Sheet: /
File: working.kicad_sch

Title: **QSPI PSRAM PMOD breakout**

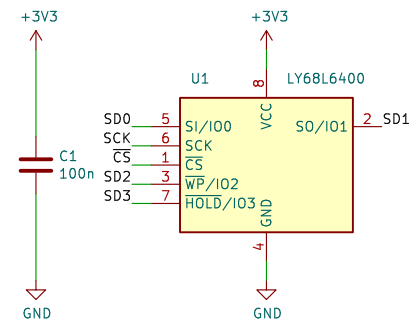
Want data bus to be on consecutive ascending GPIOs
to make things easier on the PIO side

Yup that's it
